Memorandum to the City of Markham Committee of Adjustment
March 30, 2026

File: A/018/25
Address: 189 Krieghoff Avenue, Markham
Applicant/Agent: LASONNE ENGINEERING LIMITED
Hearing Date: Wednesday, April 8, 2026

as it relates to the proposed two-storey residential dwelling.

PROPOSED SITE PLAN

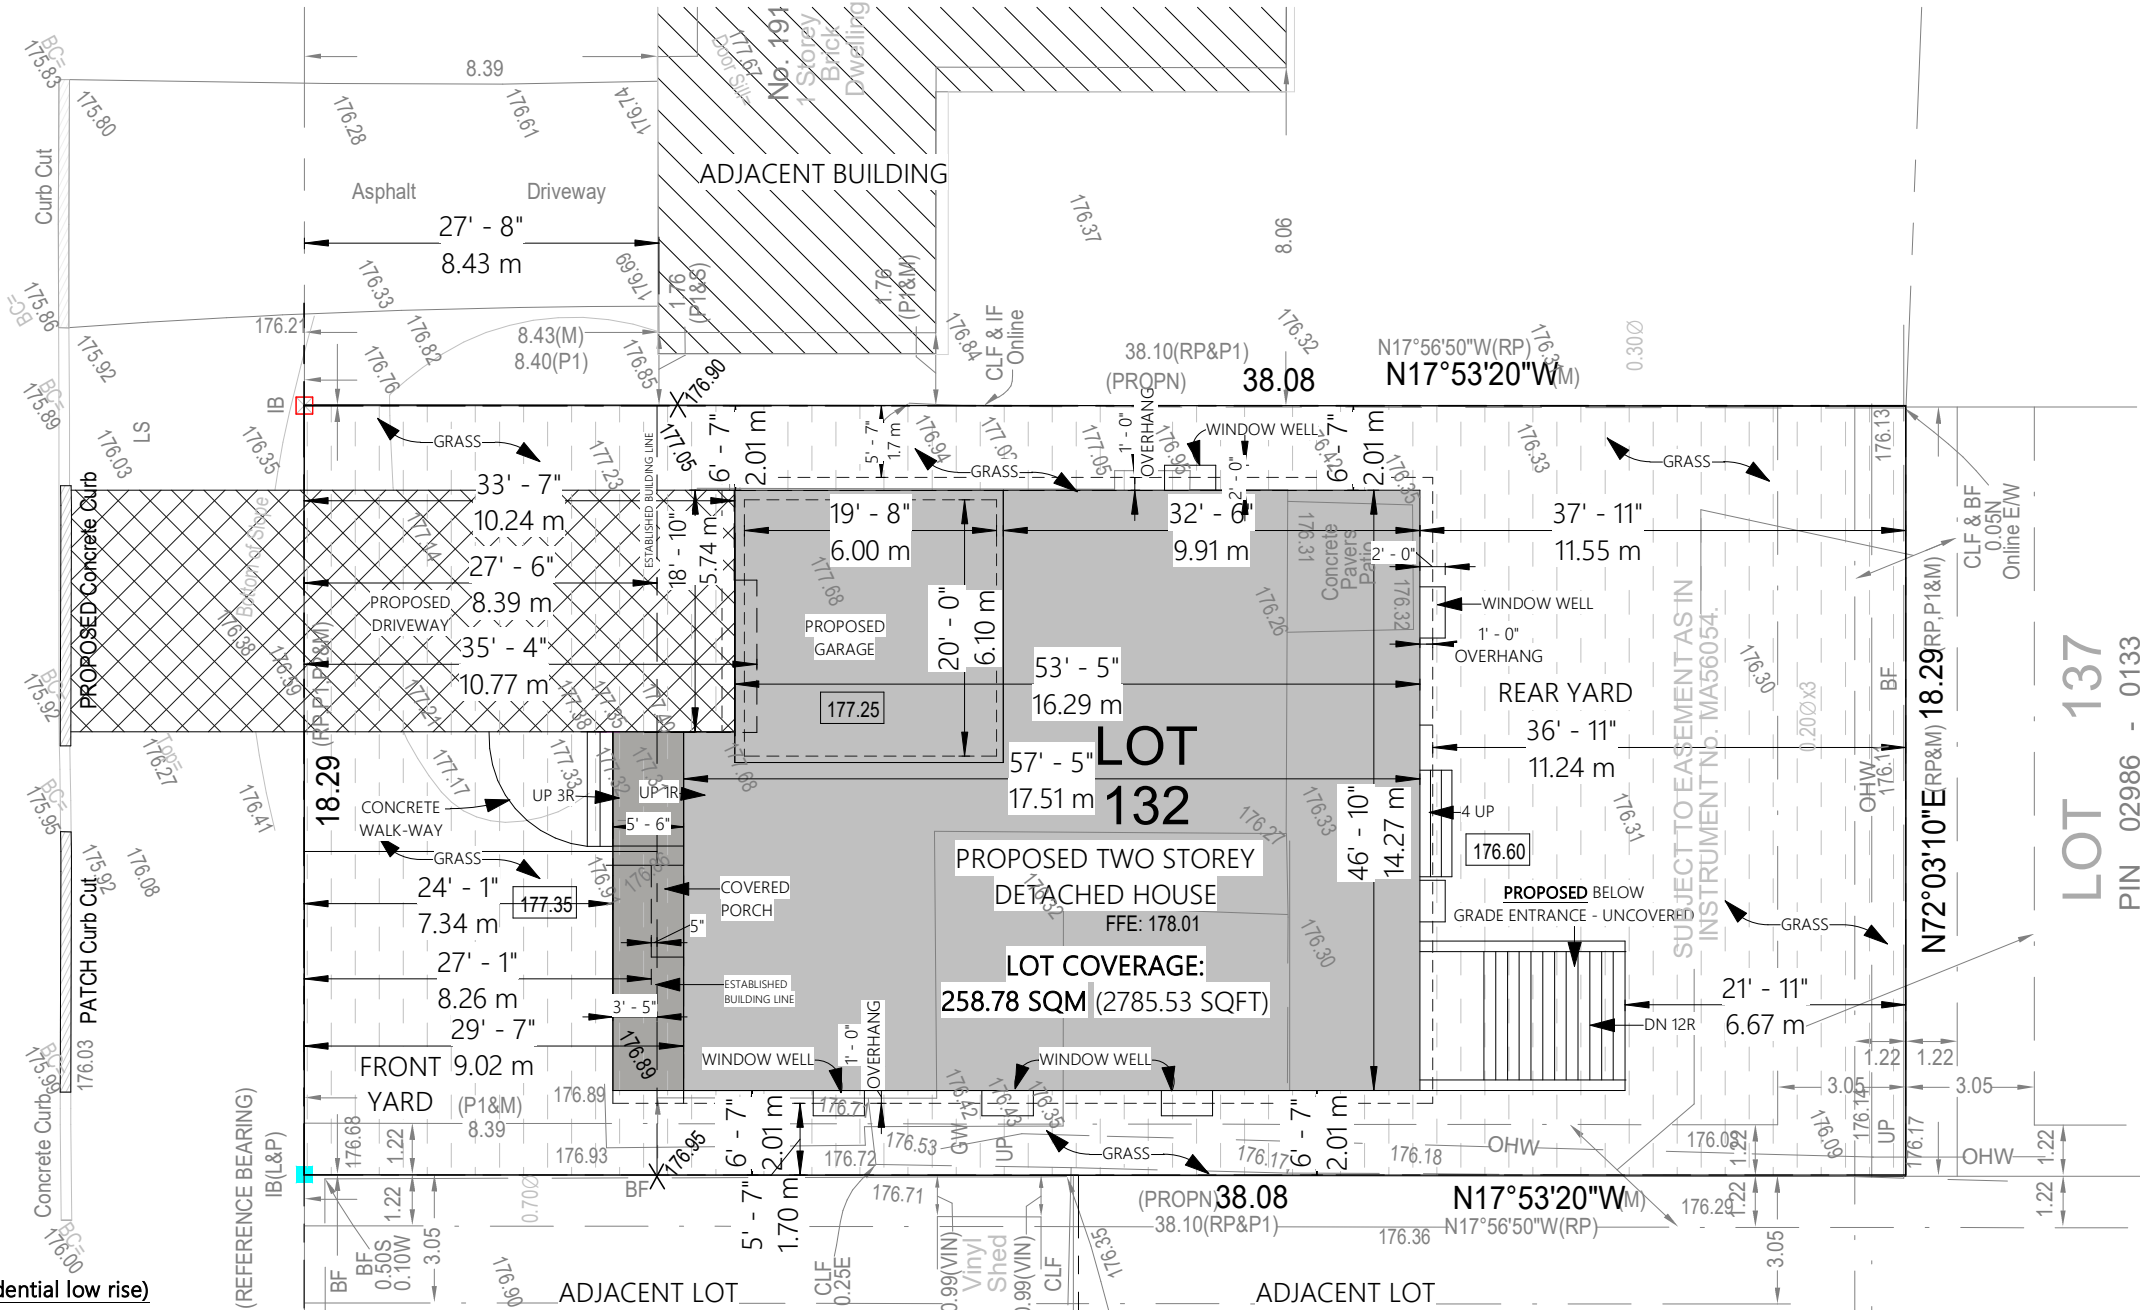
Staff note that a majority of the additional proposed lot coverage can be attributed to the 12.94 m² (139.61 ft²) front porch.

The City's Tree Preservation Staff have indicated concerns with the proposed porch location as it would further intrude into the Tree Protection Zone of a mature silver maple tree located along the boundary of the Subject Property and the adjacent property to the west at 66 Fonthill Boulevard. As the tree is a boundary tree, the Applicant would need written consent to injure from the neighbours at 66 Fonthill Boulevard prior to any construction work within the Tree Protection Zone.

As noted previously City's Tree Preservation Staff have indicated concerns with the front yard setback, particularly on the west side of the house, as it would further intrude

into the Tree Protection Zone of a maple silver maple tree located at 66 Fonthill Boulevard.

The existing dwelling on the Subject Lands provides for a 3.81 m (12.5 ft) combined interior side yard setback. This is noteworthy because the Proposed Development will be setback further from the side lot line than the existing dwelling. Staff further note that the proposed dwelling meets the By-law requirement for a minimum side yard setback of 1.8 m (5.9 ft) on either side to ensure appropriate space between properties for emergency access and soft landscaping drainage swales. Staff have no objections to the variance as proposed.

1 FRONT ELEVATION
SCALE: 3/16" = 1'-0"

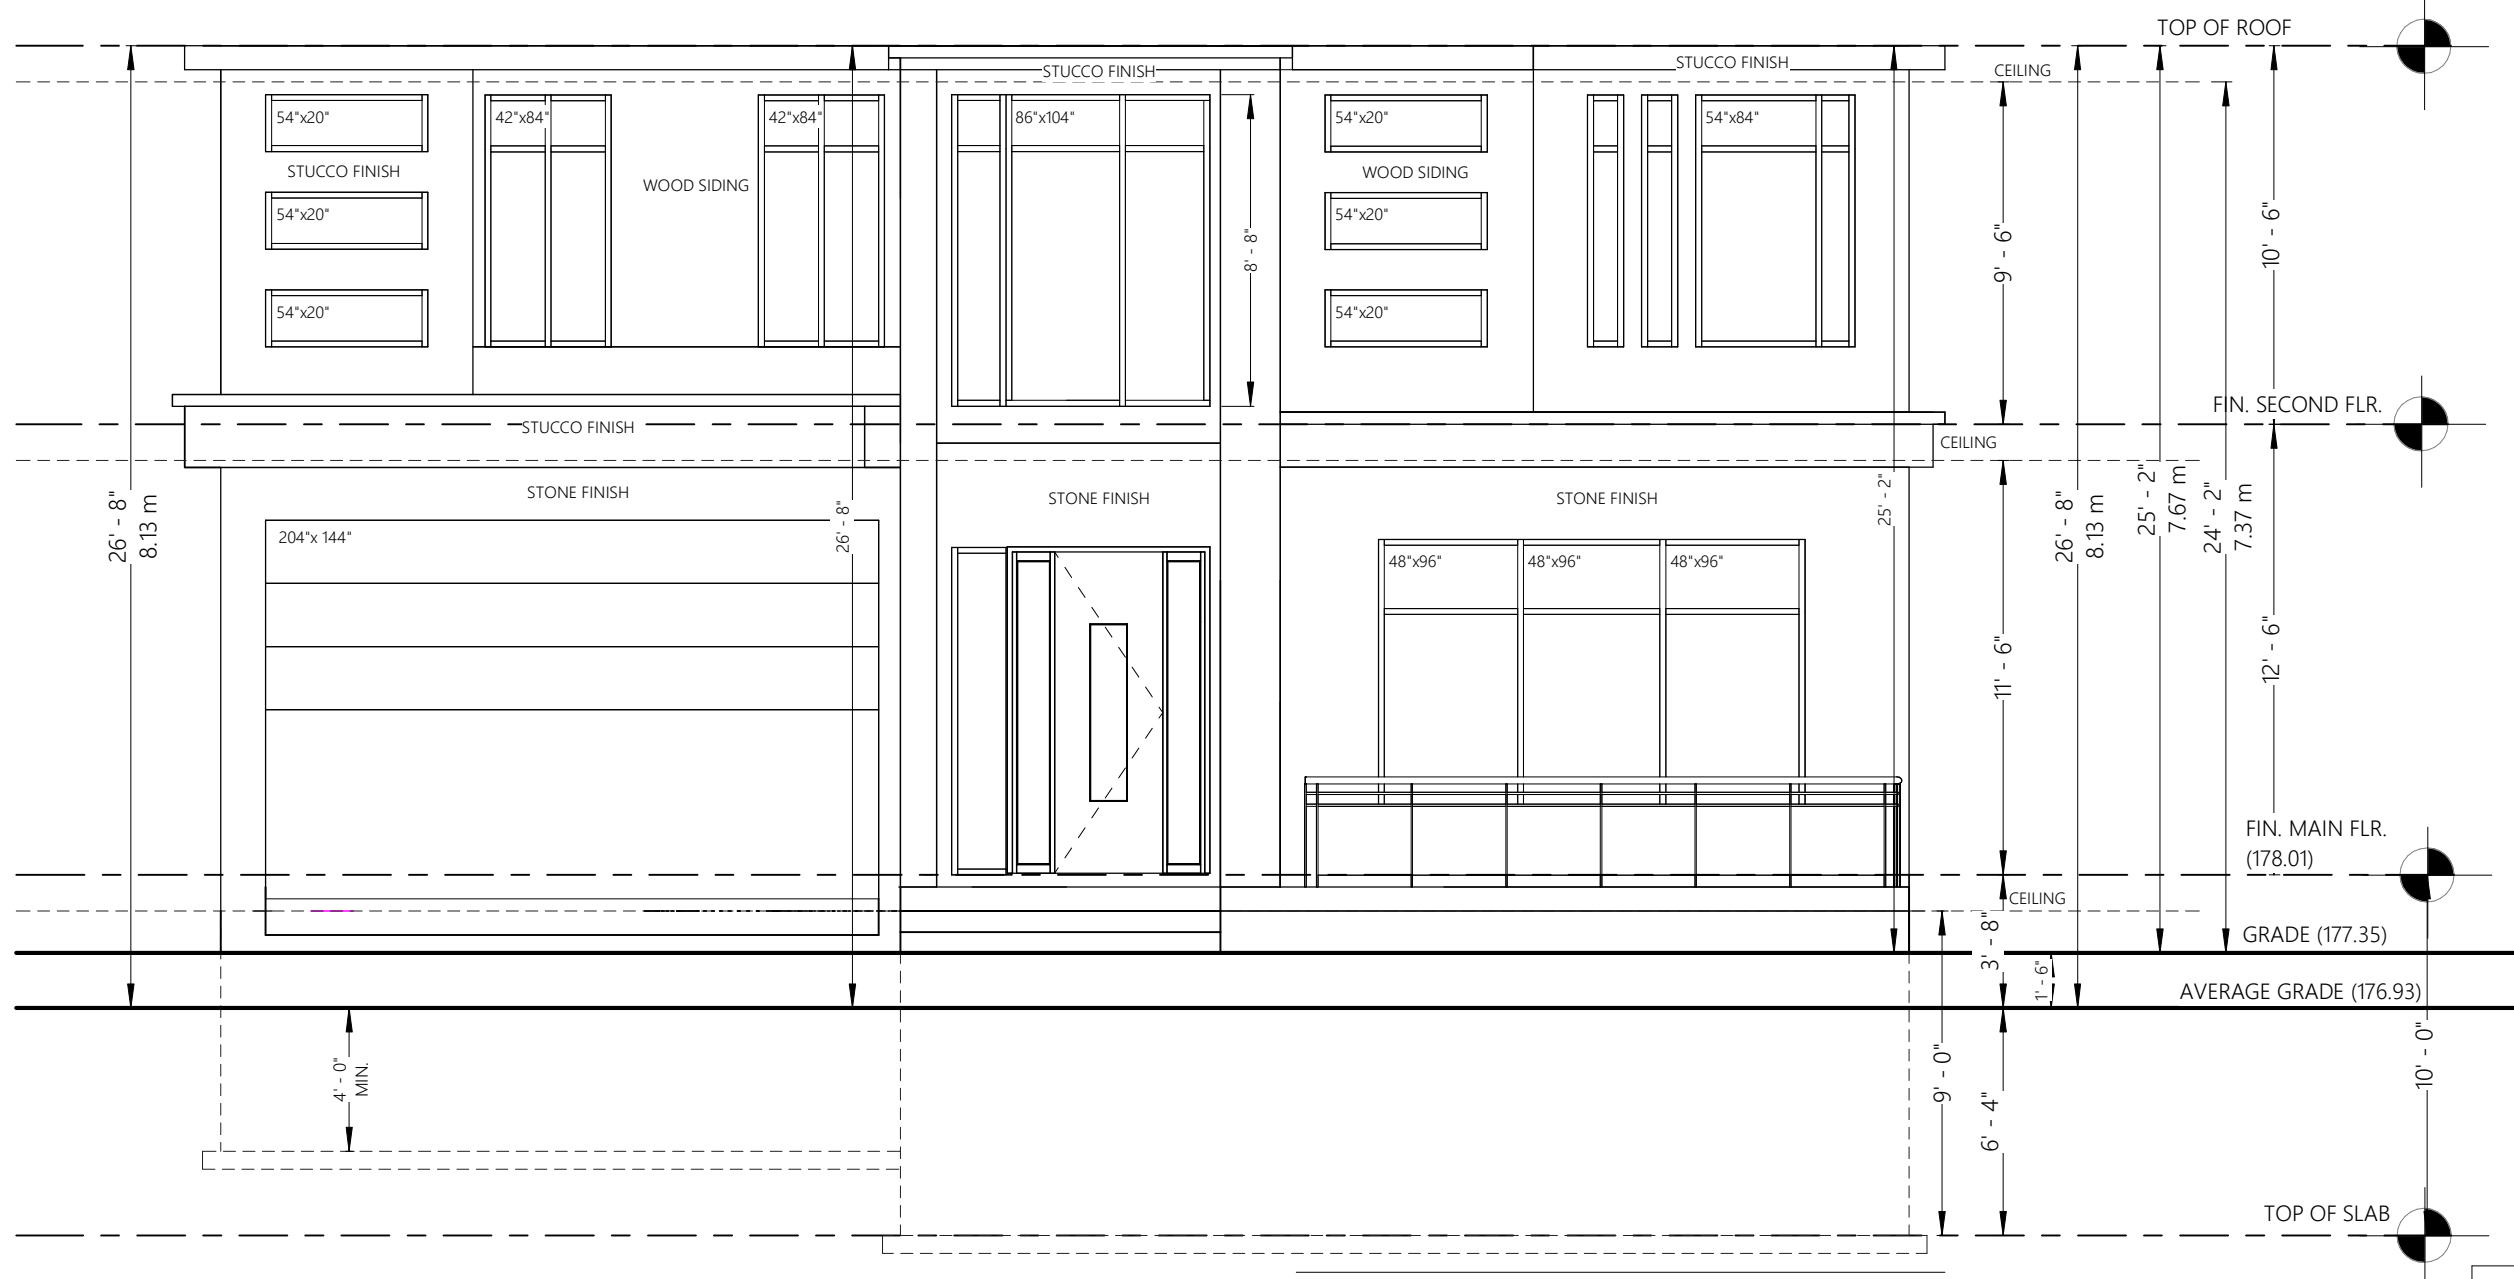
The combined effect of the increase in porch height, the projection of the porch past the established building line, porch stair projection, and the increased second storey building coverage will create a dwelling scale and massing that is uncharacteristic for the existing character of the neighbourhood and streetscape.

Staff are of the opinion that the cumulative impacts of the combined variances surrounding the porch height, projection, and stair projection coupled with the increase in building coverage and front yard setback will have a marked impact to the streetscape and character to the street. Furthermore, and as noted previously, the City's

Notwithstanding the comments noted above, Staff further note and are of the opinion that the streetscape pattern along Krieghoff Avenue is characterized by smaller, less prominent porches. Given the concerns that Staff have with the proposed porch height and projection and its impact on massing, streetscape, and tree protection, Staff are of the opinion that variance k) to reduce the porch depth is minor in nature and will serve to mitigate some of impacts to the streetscape.

The Applicant is requesting relief to permit a maximum outside wall height of 7.79 m (25.92 ft), whereas the By-law permits a maximum outside wall height of 7 m (22.97 ft). This represents an increase of 0.79 m (2.59 ft).

Initially the Applicant had requested an outside wall height of 9.05 m (29.69 ft). After further discussion with Staff, the Applicant had agreed to lower the requested variance to 7.79 m (25.92 ft) to reduce the variance by 1.26 m (4.13 ft).

Staff are of the opinion that the requested variance for outside wall height is minor in nature and is generally consistent with other infill developments in the area. However, Staff recommend that the Committee take into account the other variances being requested that would impact the surrounding character and streetscape before reaching a decision.
